Non-Concurrence Process Record for NCP-2013-013

NCP TRACKING NUMBER
NCP-2013-013

TITLE OF SUBJECT DOCUMENT Staff Evaluation and Recommendation for Japan Lessons-Learned Tier 3 Issue on Expedited Transfer of		ADAMS ACCESSION NO. ML13256A348
DOCUMENT SIGNER Michael R. Johnson		SIGNER PHONE NO. (301) 415-1713
TITLE Deputy Executive Director for Reactors and Preparedness Progra	ORGANIZATION EDO	
NAME OF NON-CONCURRING INDIVIDUAL(S) Brian Wagner		PHONE NO. (301) 251-7595
TITLE Reliability and Risk Engineer	ORGANIZATION RES/DRA/PRB

Comparison of Results for Mark I/Is

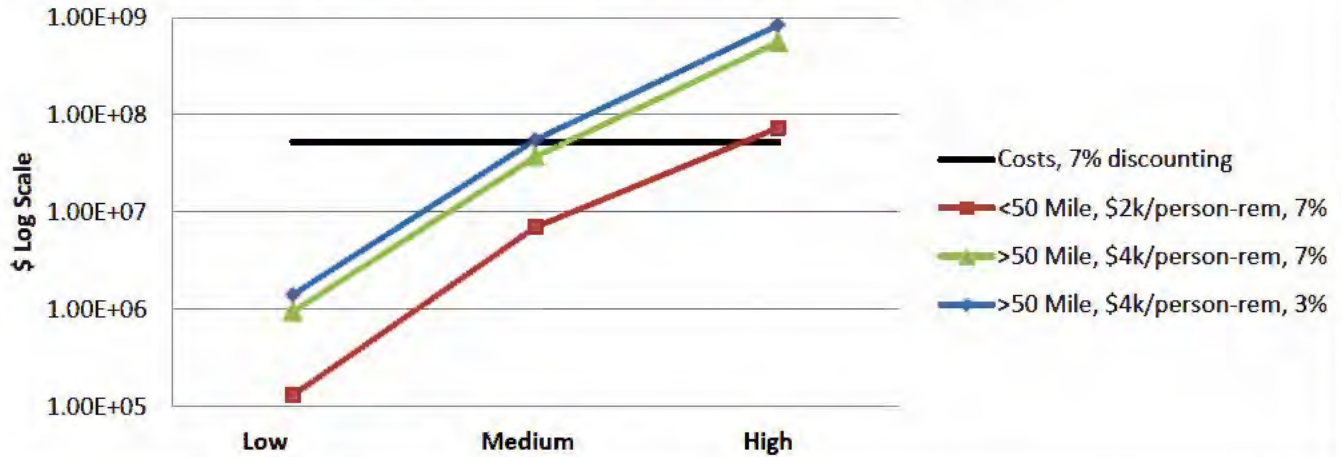
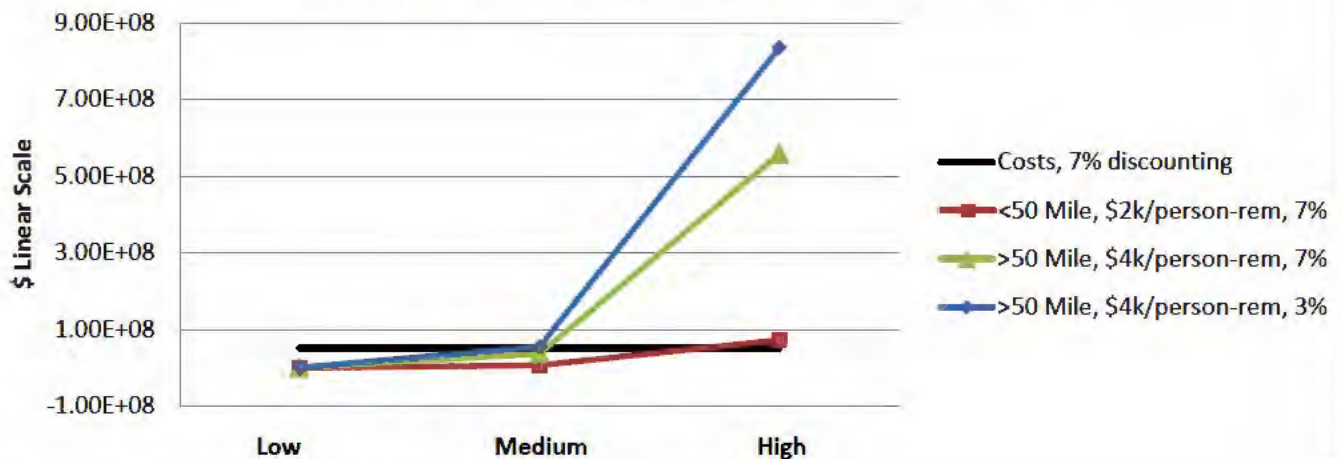
I have produced several figures and tables below to illustrate the results of the regulatory analysis. They paint a much muddier picture as to whether or not the alternative is cost-beneficial when compared to the COMSECY.

Costs are relatively insensitive to discounting.

Comparison of Results for PWR and BWR Mark IIIs

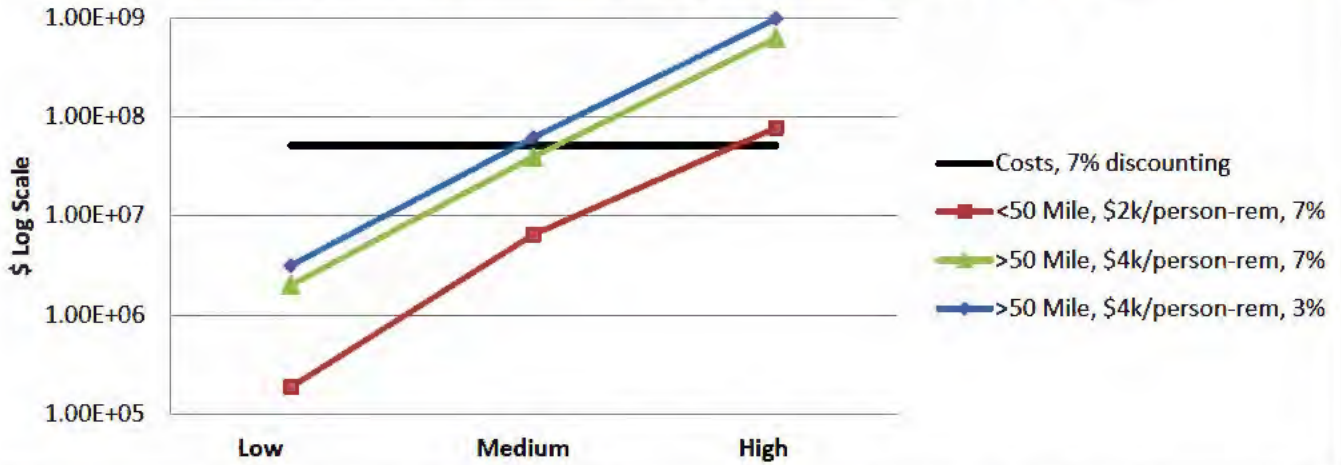
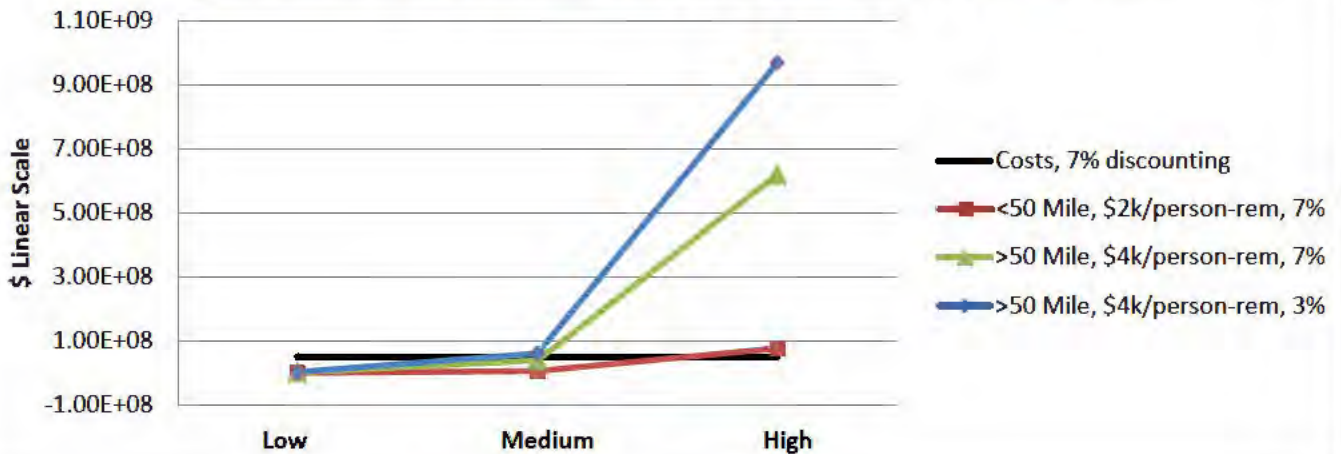
Costs are relatively insensitive to discounting.

Comparison of Results for New Rxs non-shared Pools

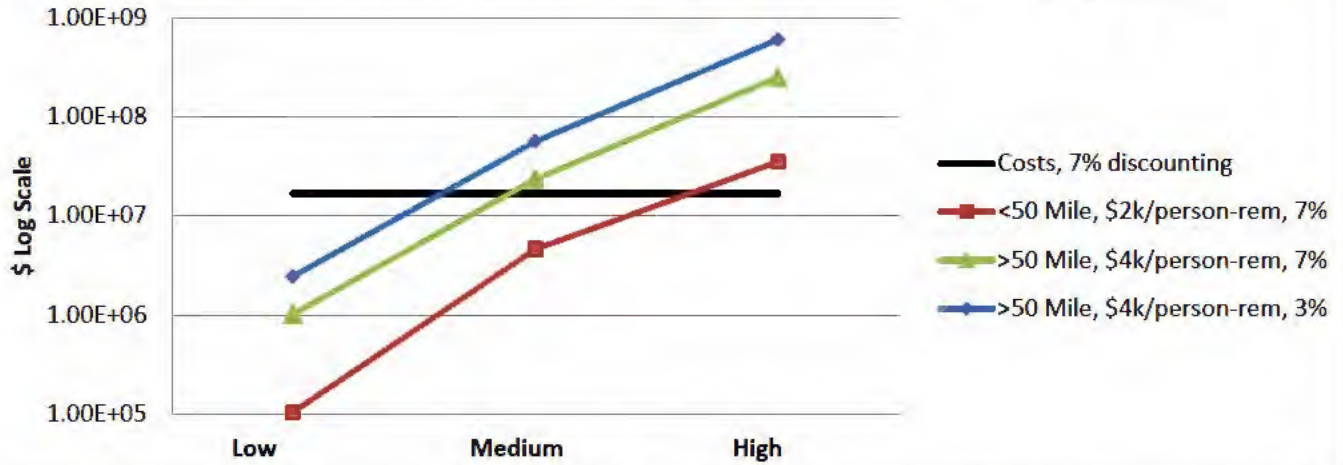
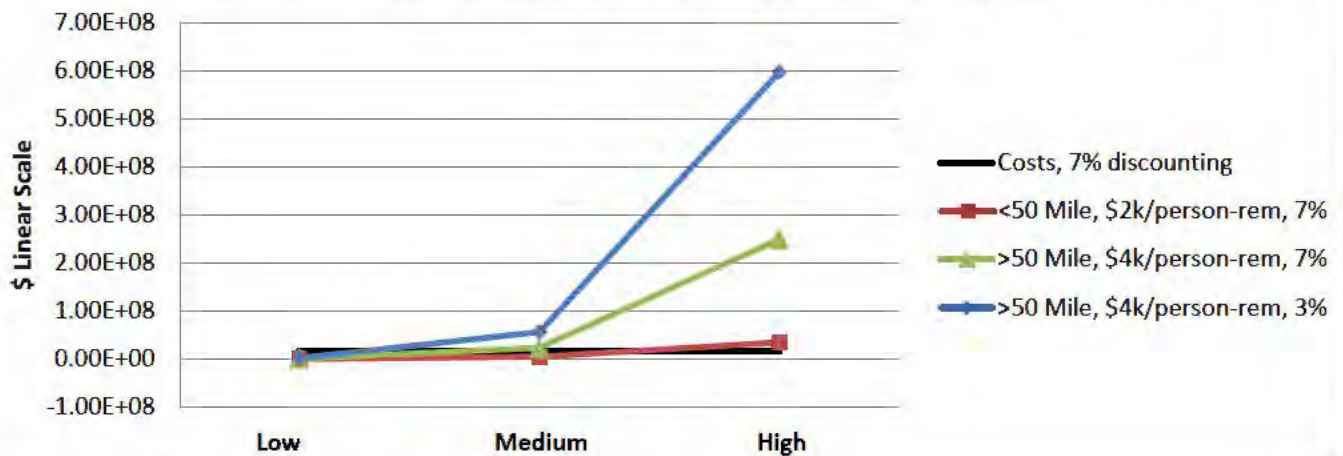
Note that for group 3 discounting costs at 3% would increase them by a factor of ~2. Not reflected in the graph.

Comparison of Results for Shared Pools

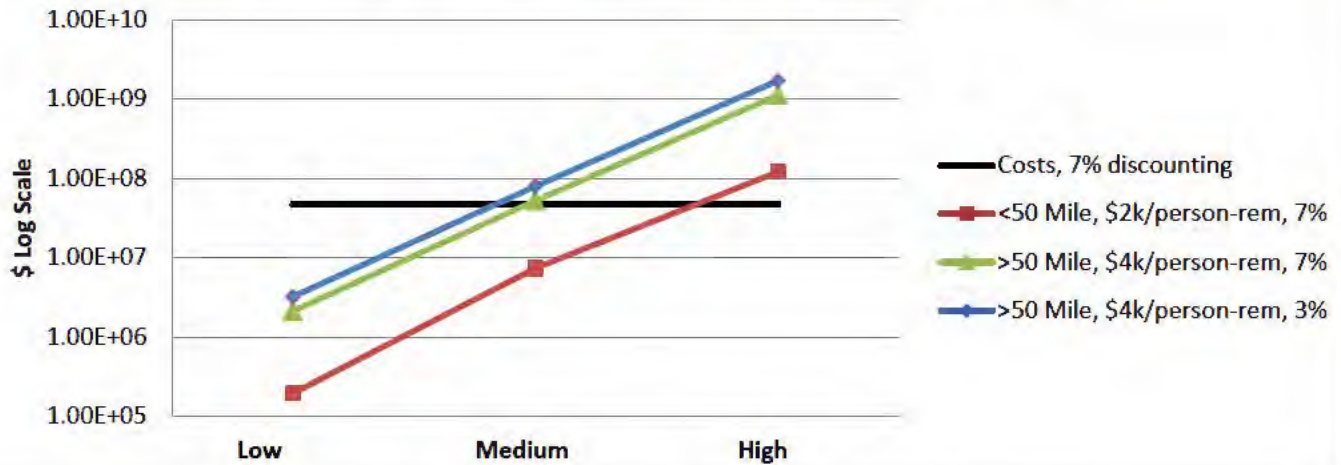
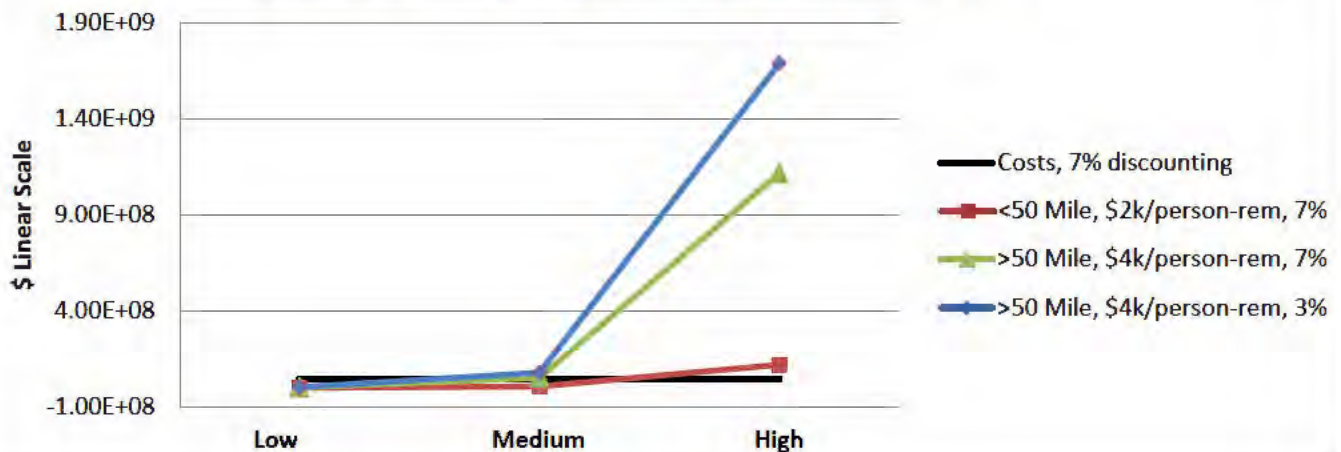
Costs are relatively insensitive to discounting.
